L624-A.07.15	<b>To:</b> Official After Sales Network <b>Subject:</b> Seat update <b>Date:</b> 02/02/15 <b>Pages:</b> 5	
--------------	--	---

Seat update

All Lamborghini Huracán Models MY 15 from VIN **FLA00163** to VIN **FLA01657**.

As a result of continuous product monitoring, Automobili Lamborghini Spa has decided to install a wiring reinforcement to prevent abrasion during seat movement.

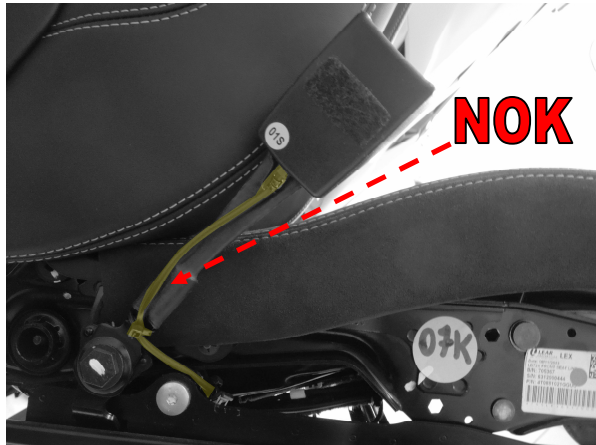
12. Cover the wire on vehicle cockpit platform with the protective sheath.

13. Fix the sheath to the wire by wrapping it with tissue adhesive tape al long its length.

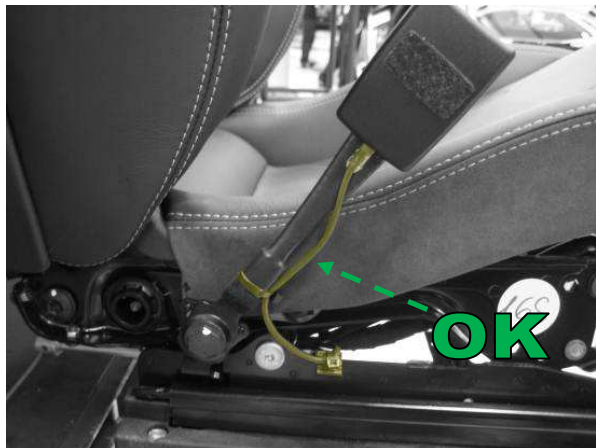
14. Change routing of the seat belt buckle wiring.

When the buckle wire is placed onto the external side of the buckle stem facing the tunnel, it must be routed again.

Remove the clamp on the buckle and release the electrical wiring.

Clamp the electrical wiring so that the wire is placed on the thin side of the buckle stem.
